STAFF REPORT AMENDED 6-9-83
CITY PLANNING COMMISSION

APPLICANT	Robert J. Feusi, C.E. - 4449 Edison Avenue, Sacramento, CA 95821				
OWNER	Ollie & Annie Bailey - 5216 Ehrhardt Avenue, Sacramento, CA 95823				
PLANS BY	Robert J. Feusi, C.E. - 4449 Edison Avenue, Sacramento, CA 95821				
FILING DATE	4-26-83	50 DAY CPC ACTION DATE		REPORT BY:	JP:sg
NEGATIVE DEC.	5-27-83	EIR		ASSESSOR'S PCL. NO.	117-132-19

- APPLICATION:
1. Negative Declaration
 2. Rezone from Agricultural (A) to Single Family (R-1)
 3. Tentative Map to divide 1± acre into 2 parcels
 4. Subdivision Modification to create a flag-shaped lot (withdrawn)
 5. Subdivision Modification to create a lot in excess of 160 feet deep
 6. Subdivision Modification to waive sewer and water services to Parcel B

LOCATION: 5216 Ehrhardt Avenue

Exhibit A

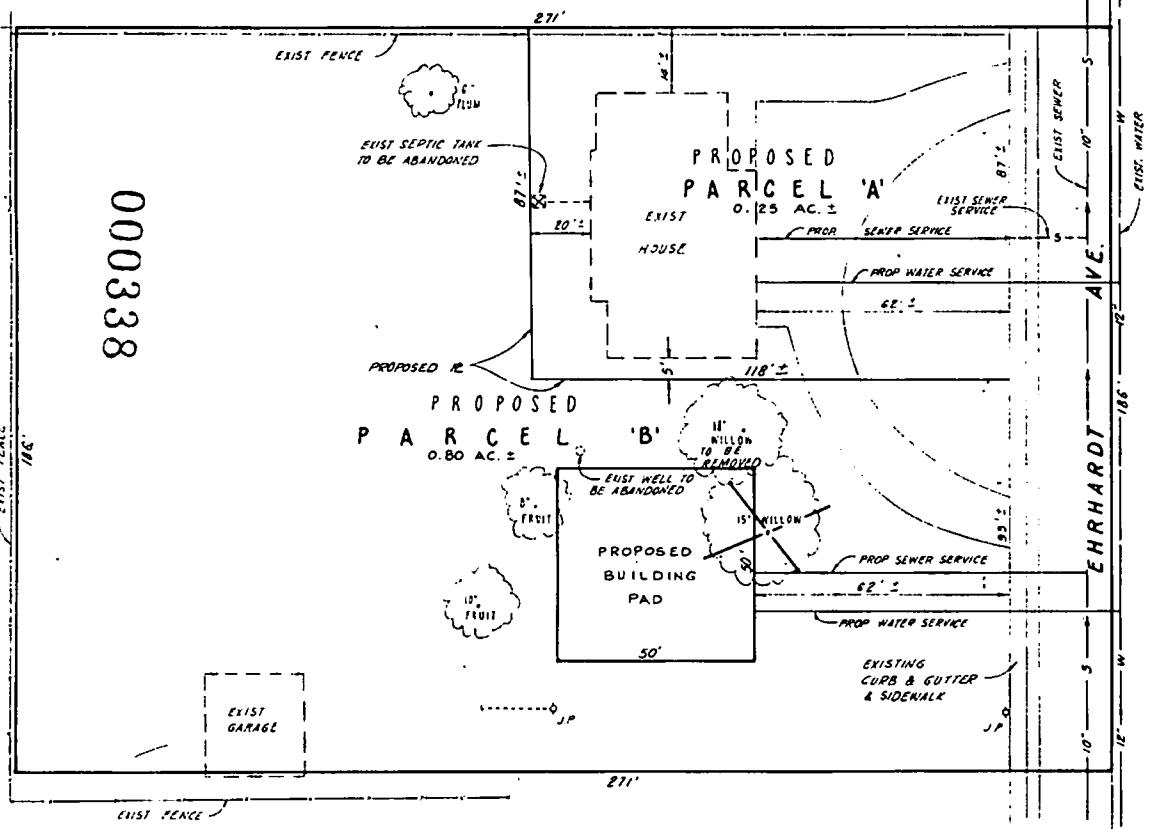
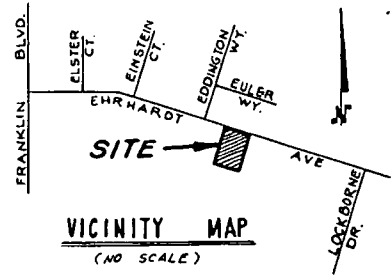
1. The subject site consists of a 50,406 square foot (1.16 acre) parcel with one single family residence and a detached garage (Exhibit A) in the Agricultural (A) zone. The applicant proposes to split the parcel into two lots in order to build a new single family residence (Exhibits B and C). The applicant anticipates selling the parcel on which the existing residence is located after construction of the new home has been completed.

3. The new parcel created by the lot split will have the detached garage located on it while the existing residence will be located on the other parcel. According to the Zoning Ordinance, detached accessory structures must be located on the same parcel as the main structure. The applicant, however, desires to use the existing garage as an accessory structure for the residence proposed for the new parcel. Staff recommends that the applicant post a bond on the existing garage until the new residence is constructed. If the residence is not constructed, the applicant will be required to remove the garage from the parcel.

In addition, approximately one foot of the east side of the detached garage is located on the adjacent property to the east. The applicant shall be required to have the detached structure located entirely on the subject site or remove the garage before the filing of the final map.

- c. Eliminate circular driveway.
- d. The applicant shall remove the existing garage on Parcel B or bring it into conformance with the Zoning and Subdivision Ordinances prior to the filing of the final map.

Exhibit B

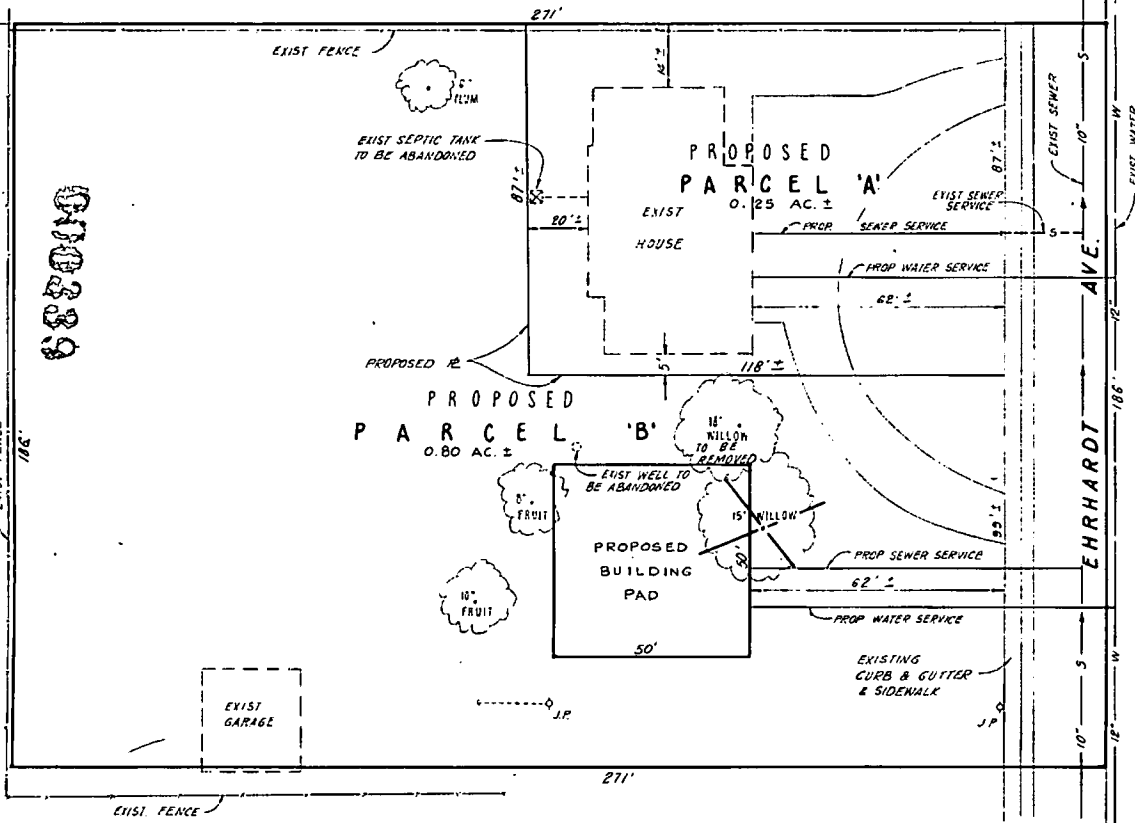
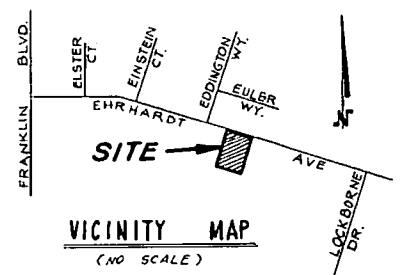
4. The Water and Sewer Department has requested that a note be placed on the final map stating that water and sewer service connections do not exist between the main lines and Parcel B. These services must be paid for and installed at the time of obtaining building permits.

6. The Traffic Engineering Department has requested that the circular driveway be eliminated.
7. Staff has no objection to the proposed rezoning and division of the subject site. The parcel is in an area that is currently being developed with single family residences. The proposed development will not change the character of the area as single family residences are allowed under the General Plan and the Valley Hi Community Plan. In addition, the rear portion of Parcel B can be further subdivided in the future as indicated in Exhibit D.

- a. Place the following note on the final map: Water and sewer service connections do not exist between the main lines and Parcel B. These services must be paid for and installed at the time of obtaining building permits.

Exhibit D

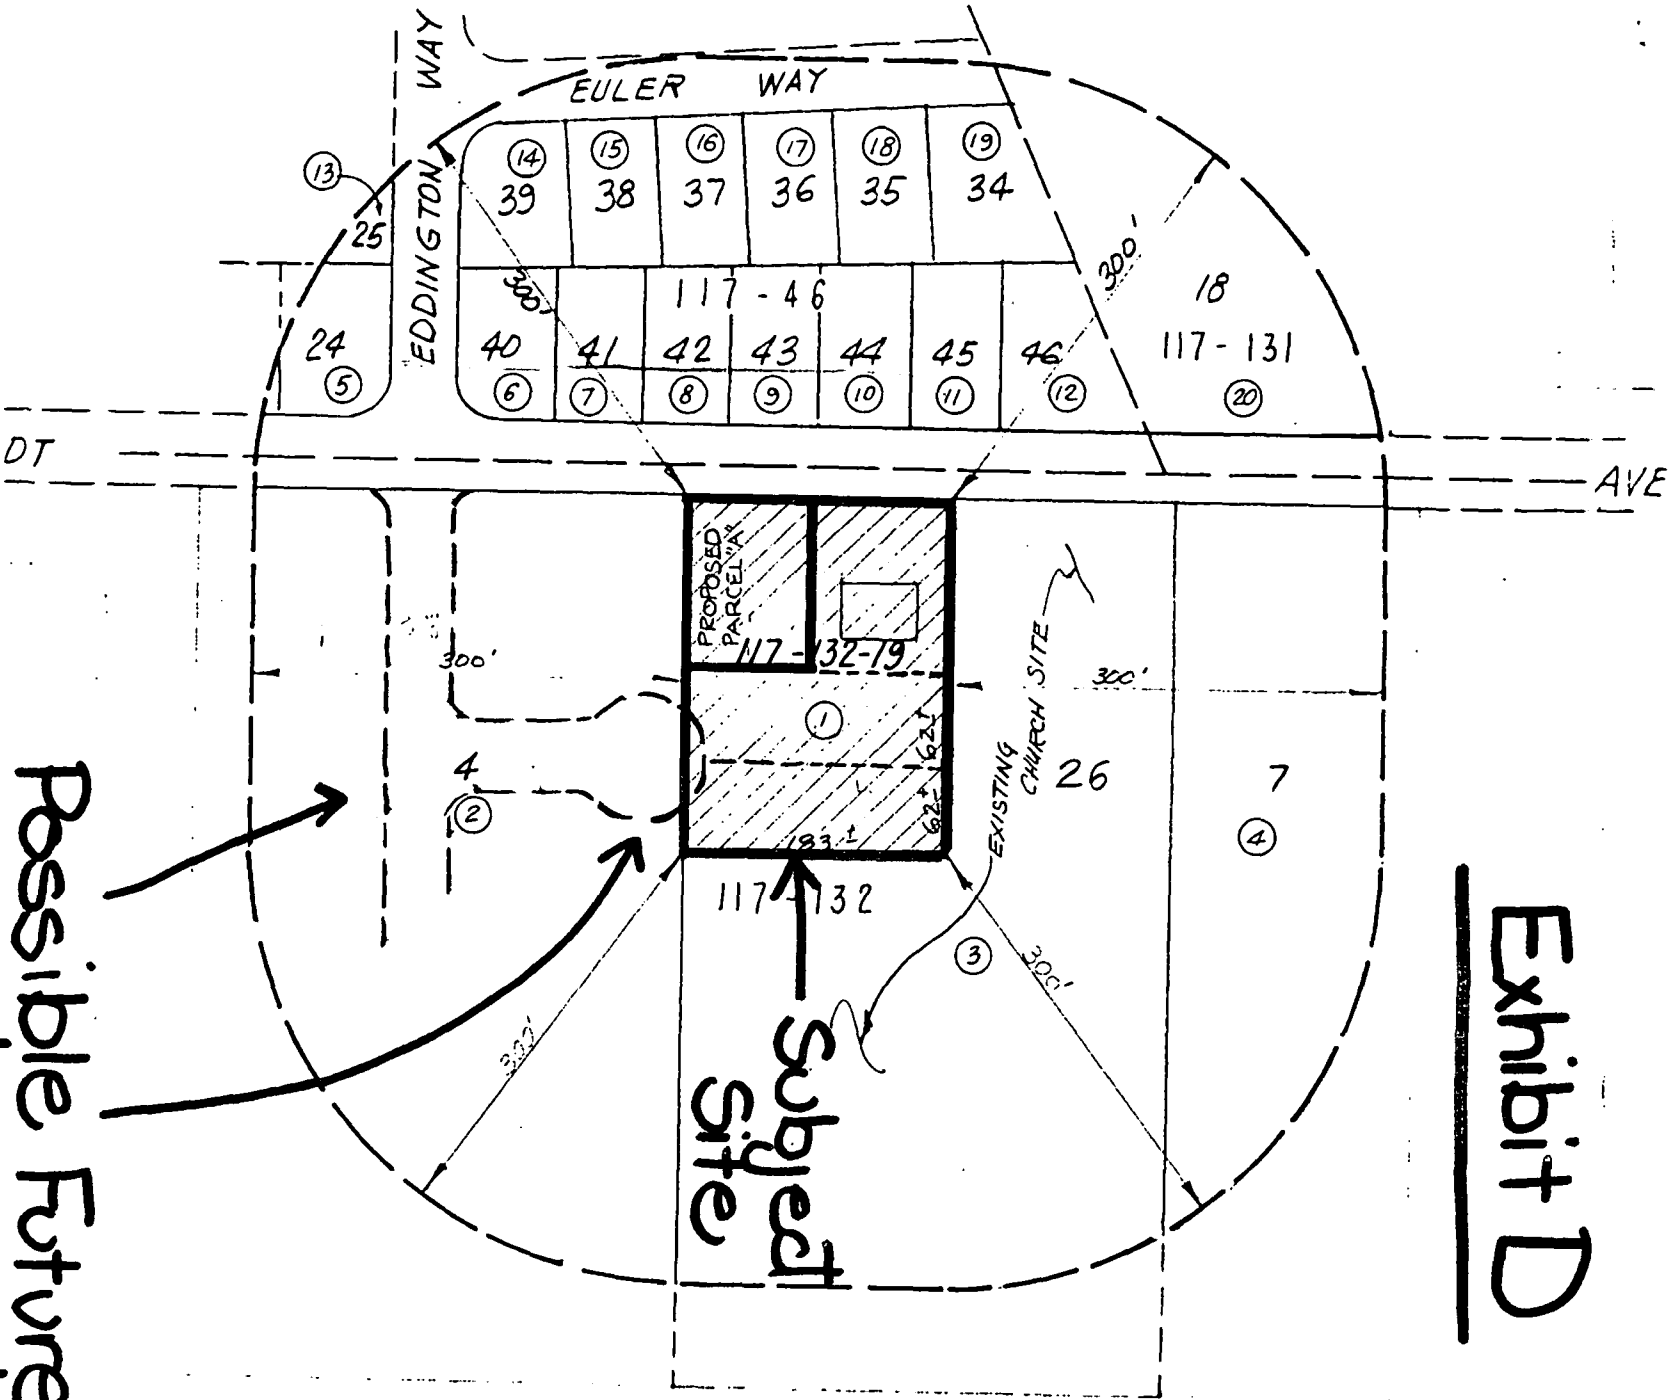
2. In splitting the parcel, the applicant will have created a flag-shaped lot in excess of 160 feet deep. While the creation of flag-shaped lots are discouraged, it would be possible in the future to further subdivide this lot (Exhibit D). This lot conforms to the minimum frontage requirements as it has over 52 feet of street frontage. Staff, therefore, has no objection to the creation or the depth of the flag-shaped parcel. A subdivision modification for the flag-shaped lot is not necessary and has been withdrawn.
